Smaller footprint layout that could be used if volumes with uninflated 2030 volumes

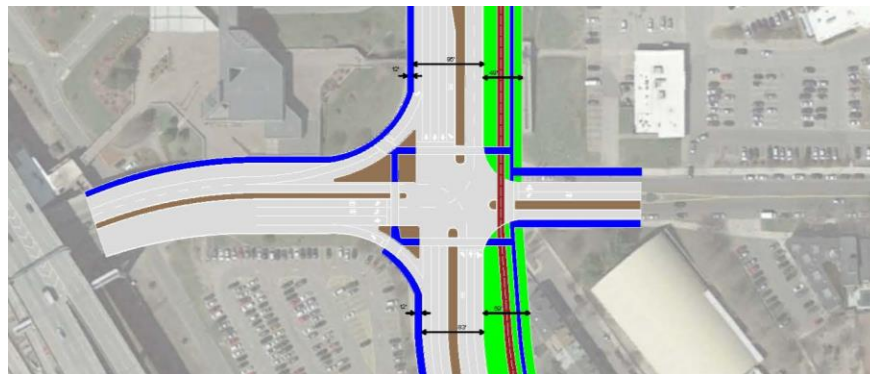
Omitting the questionable inflation factors mentioned earlier – and thus providing sufficient capacity for traffic projected in 2030 for the peak hour – it becomes possible to carry the traffic with a smaller footprint road, shown below. This option has only one left turn lane, and the linear park south of Austin Street is 11 ft wider. (North of Austin Street, the road footprint is unchanged.) In the a.m. peak, the most congested approach has a volume/capacity ratio of 0.94, and average delay is 52 s.

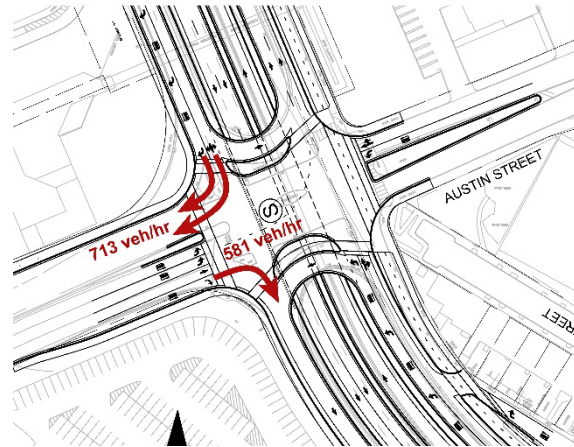
The layout for the City's underpass option can be found at the project website. The City provided us with their proposed signal timing plan and capacity / delay analysis made using Synchro.

The layout of the underpass option (see figure below) looks pedestrian-friendly – there are crosswalks across all four legs of the intersection, there are no delta islands with slip lanes for right turning traffic, and the Austin Street crosswalks are drawn in a way that shows that pedestrians there will have simple, one-stage crossings.

**Split intersections result in interlocking lefts, which prevent left turns from running concurrently**

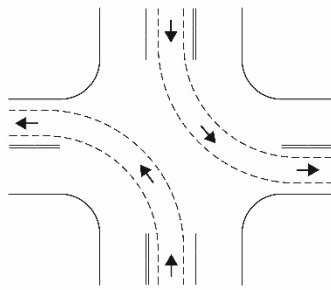
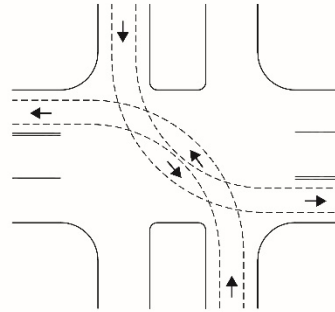
Second, ***an underpass creates a split intersection.*** The northbound and southbound surface roads will be separated from one another by about 60 ft. As a result, left turns cannot run concurrently, because they interlock, as illustrated in the figure below. The traffic signal plan is therefore forced to follow an arrangement called “split phasing,” in which each of the four legs has a turn in sequence. Split phasing is both less flexible and less efficient than the normal phase sequence in which opposite directions (e.g., northbound and southbound) run concurrently. One can observe this inefficiency at other intersections with underpasses, such as Mass Ave @ Commonwealth Ave and Mass Ave @ Huntington Ave in Boston, where traffic on the surface roads is often backed up.

Lefts at compact intersections do not conflict.

Interlocking lefts at split intersections cannot run concurrently.
